## Design change affecting tensioner lever 534 0100 20

534 0100 20

**INA 0042**

Figure 1: 534 0100 20 - current design

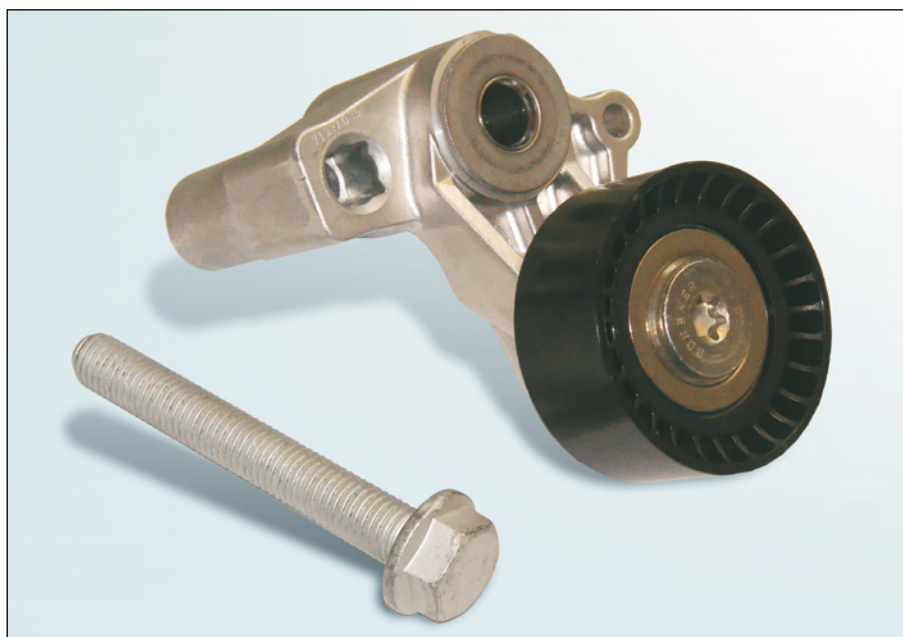
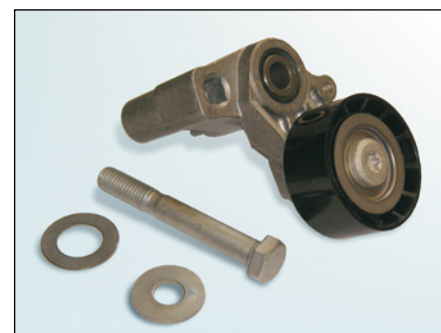
As part of our continuous efforts to improve our products, changes have been made to the design of tensioner lever 534 0100 20. The accessory parts which were previously loose (washers) are now fixed to the tensioner lever. The fixing bolt has also been modified.

During the transitional phase, we may have mixed stocks of both types. Both versions fulfil the relevant technical specification and can be used without restrictions.

Only the new screw supplied can be used with the new design. Other screws or older screws are not permitted! Use the torque prescribed by the vehicle manufacturer to tighten the fixing bolt.
